INNOVATEC			
File		SCH: NCI	
Size	Document Number	971-00003	
B		Rev	5.10
Date:	Monday, January 08, 2001	Sheet	1 of 4

Title		
SCH: NCI, IF SAW FILTER AND DEMODULATOR		
Size	Document Number	Rev
B	971-00003	5.10
Date:	Monday, January 08, 2001	Sheet 4 of 4

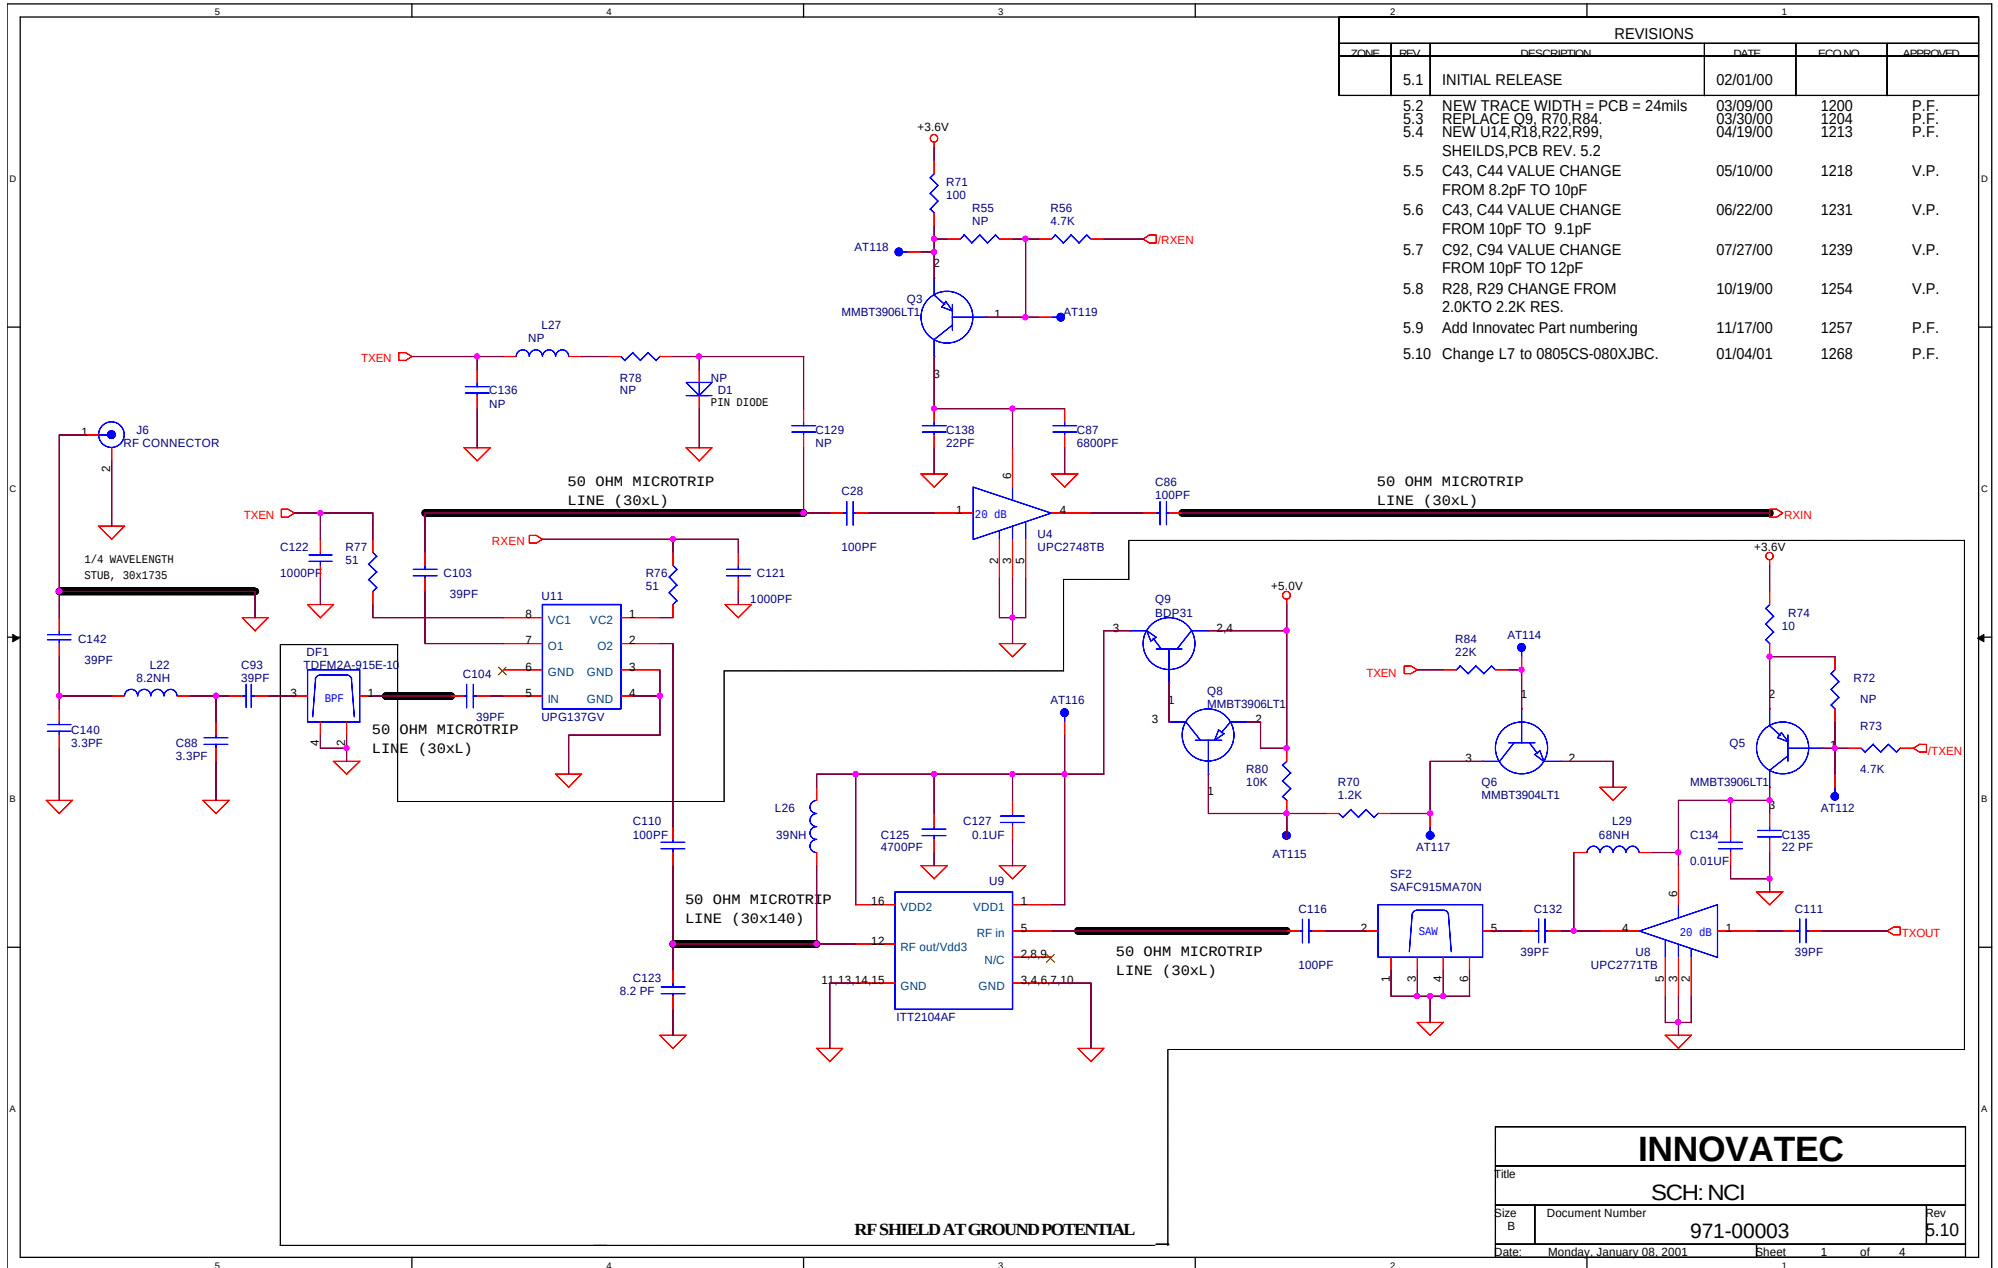
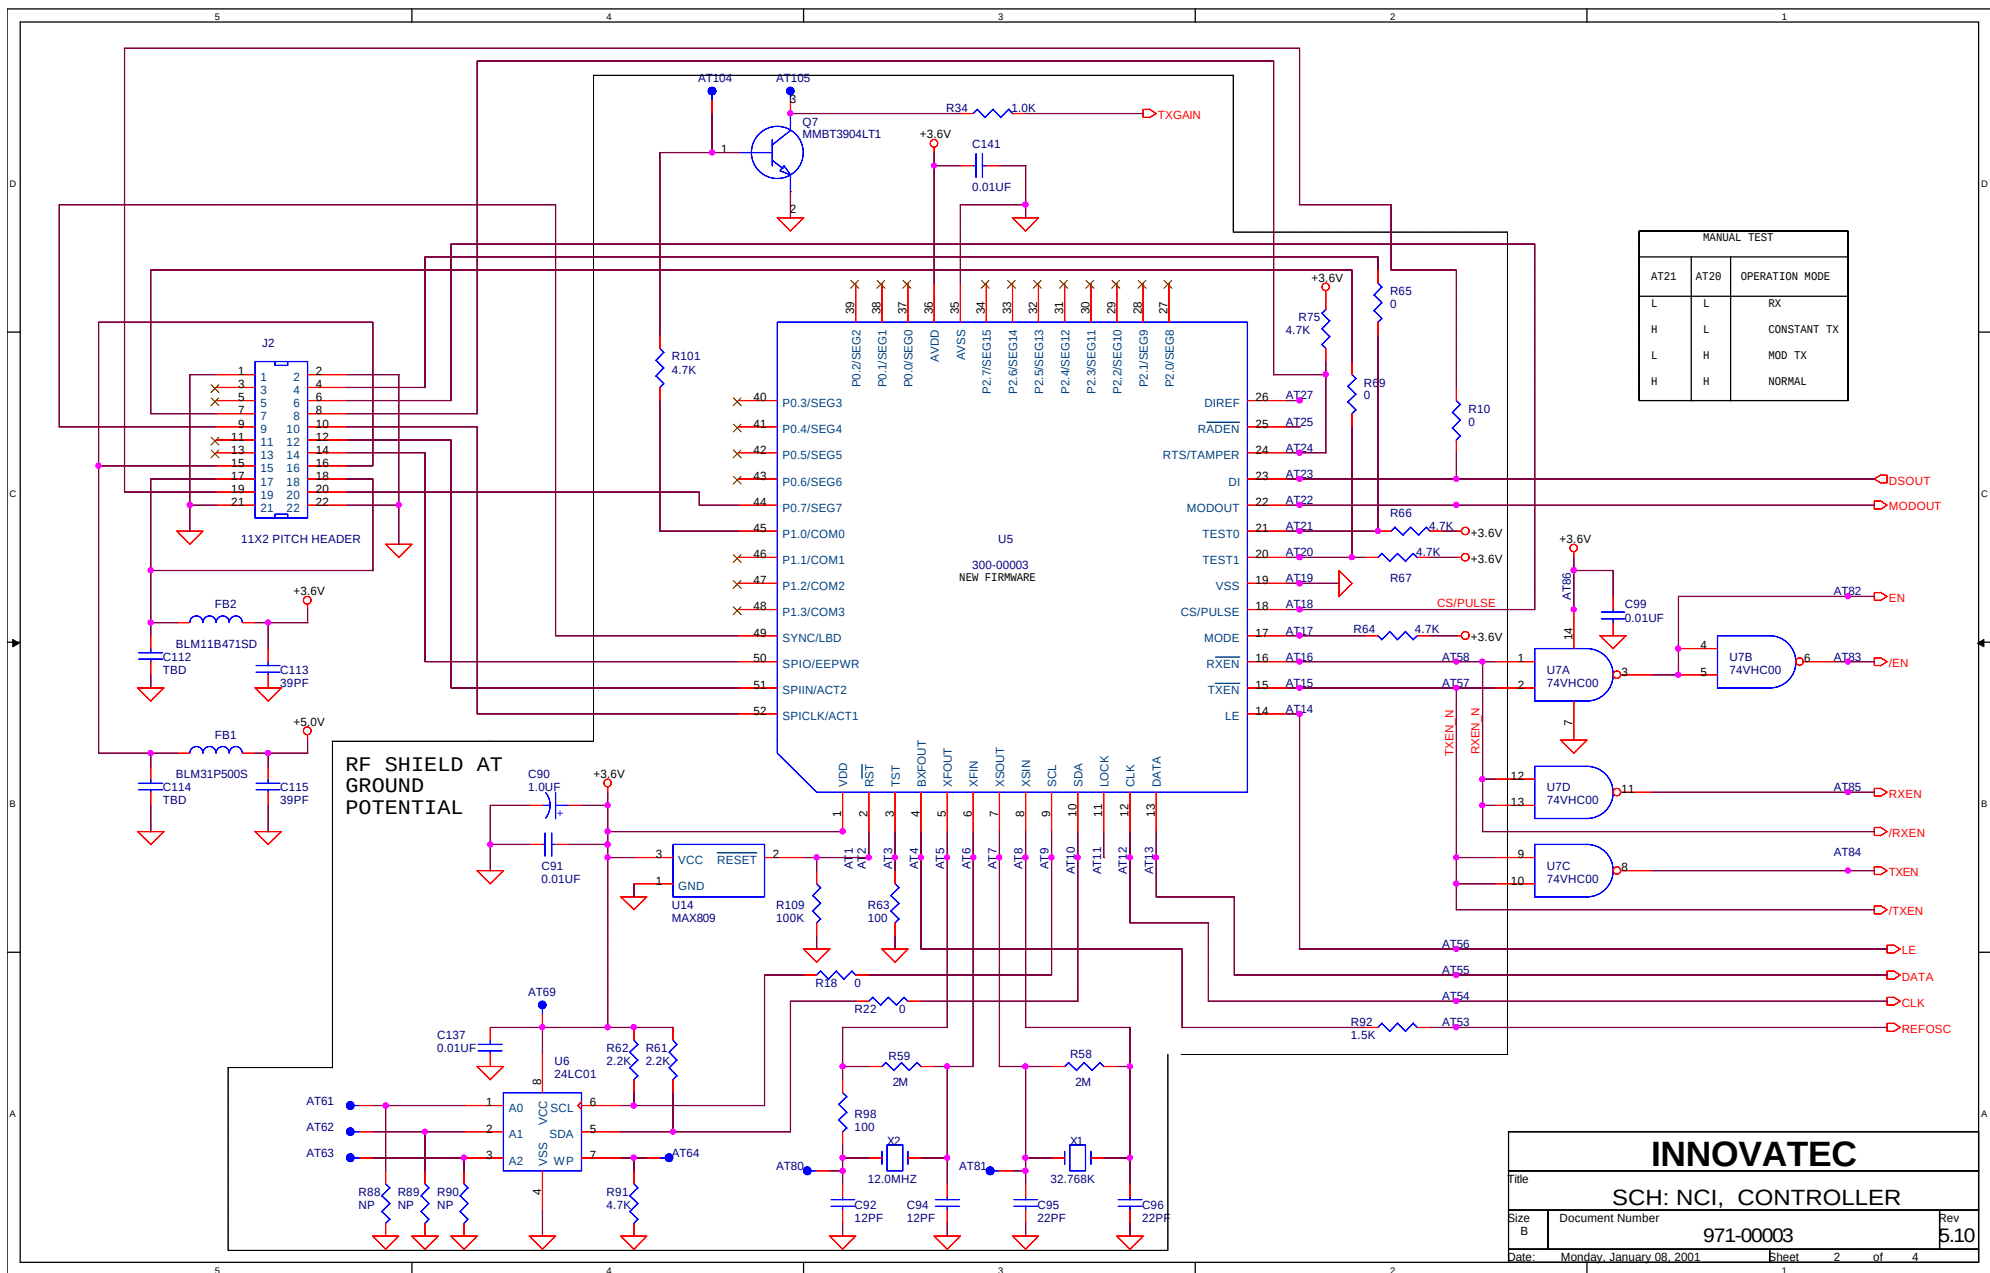
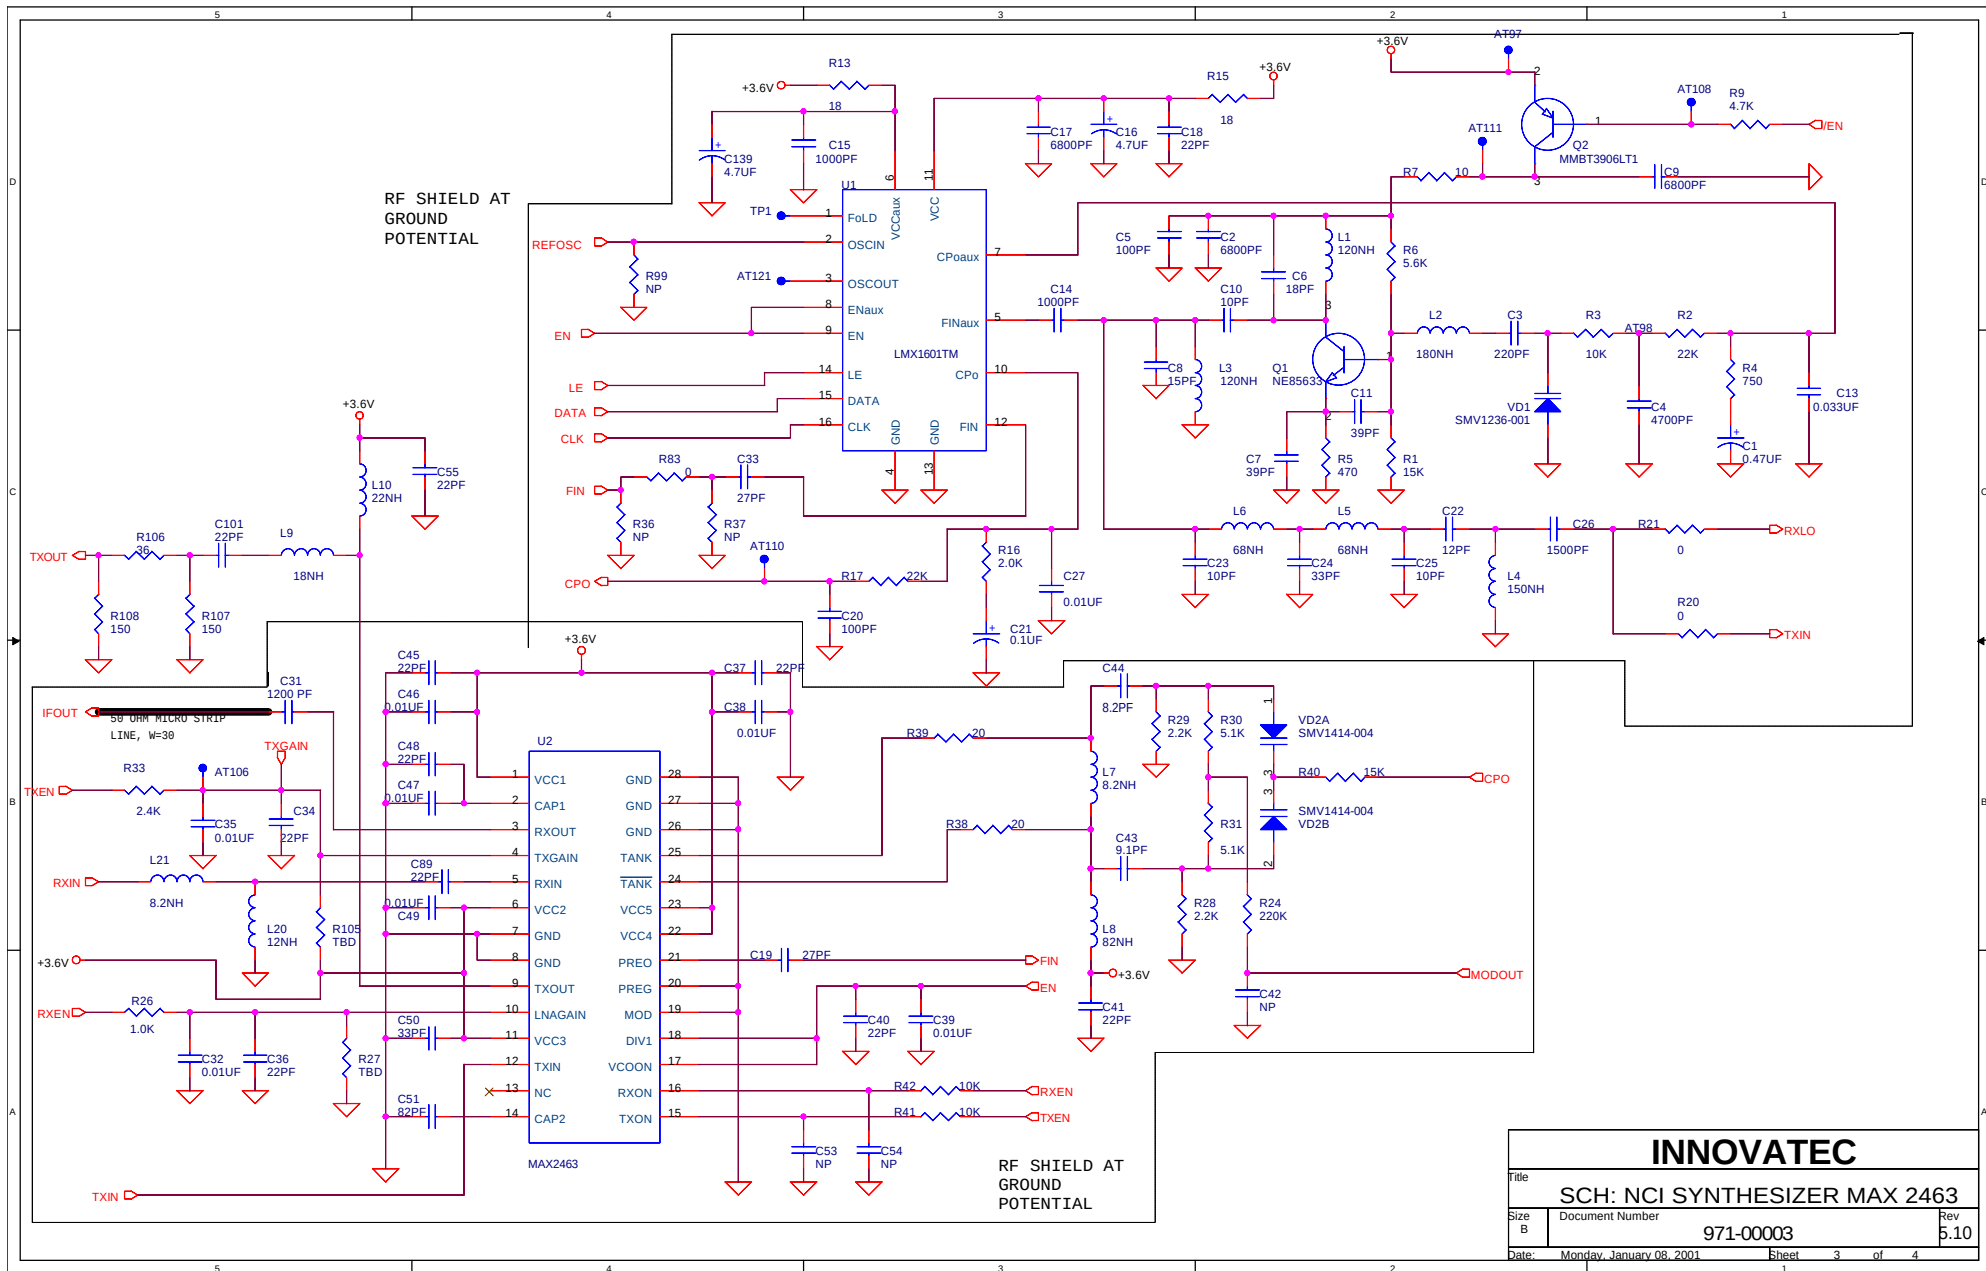
REVISIONS				
ZONE	REV	DESCRIPTION	DATE	ECNO
	5.1	INITIAL RELEASE	02/01/00	
	5.2	NEW TRACE WIDTH = PCB = 24mils	03/09/00	1200
	5.3	REPLACE Q9, R70, R84,	03/30/00	1204
	5.4	NEW U14, R18, R22, R99, SHEILDS, PCB REV. 5.2	04/19/00	1213
	5.5	C43, C44 VALUE CHANGE FROM 8.2pF TO 10pF	05/10/00	1218
	5.6	C43, C44 VALUE CHANGE FROM 10pF TO 9.1pF	06/22/00	1231
	5.7	C92, C94 VALUE CHANGE FROM 10pF TO 12pF	07/27/00	1239
	5.8	R28, R29 CHANGE FROM 2.0K TO 2.2K RES.	10/19/00	1254
	5.9	Add Innovatec Part numbering	11/17/00	1257
	5.10	Change L7 to 0805CS-080XJBC.	01/04/01	1268
